SERVICE BULLETIN

Subject: Motor Overload Relay

Bulletin No. SB09-5

Figure 1

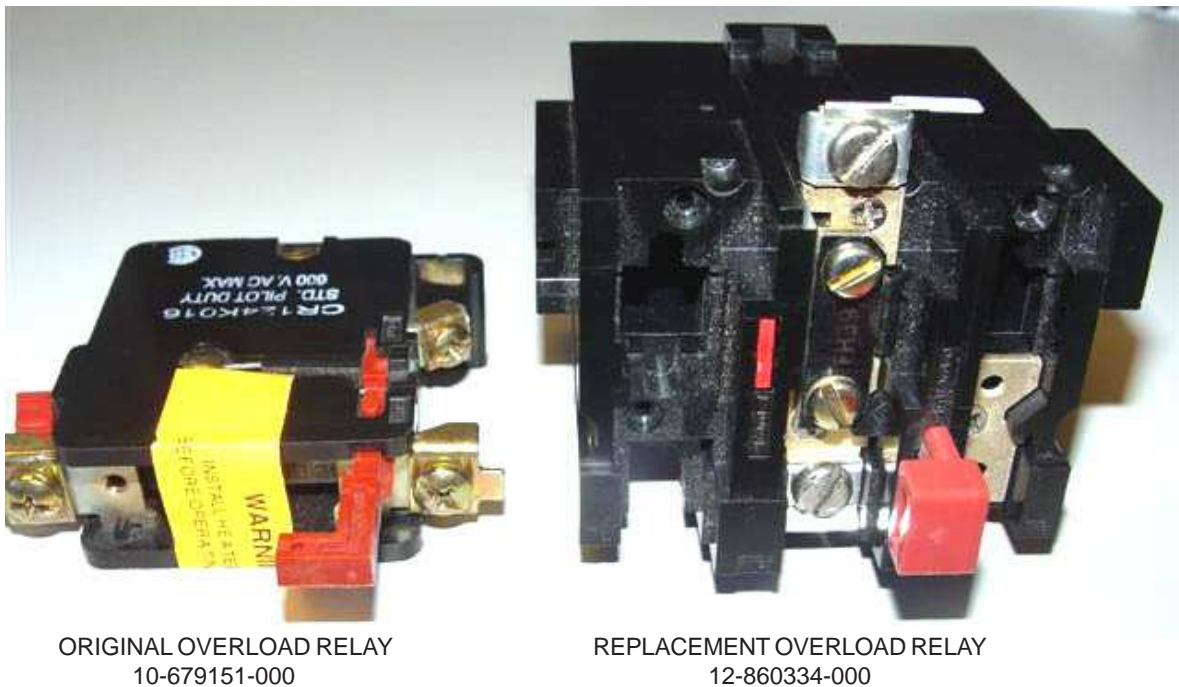
This Bulletin is to inform A and A-2 pinsetter customers that the Motor Overload Relay, part number 10-679151-000, is no longer available. Critical components to the original relay can no longer be manufactured by the supplier. This relay is used to protect the pinsetter motor and electronics when the motor starts to draw excessive amps during operation.

To continue supporting Pinsetters that utilize this relay, a replacement has been designed. The replacement overload relay performs the same as the original, but is larger with different dimensions, and requires modification to the electrical box to operate safely. Instructions will be provided when a replacement relay is ordered to make this modification. The part number of the replacement Motor Overload Relay is 12-860334-000. Refer to *Figure 1*.
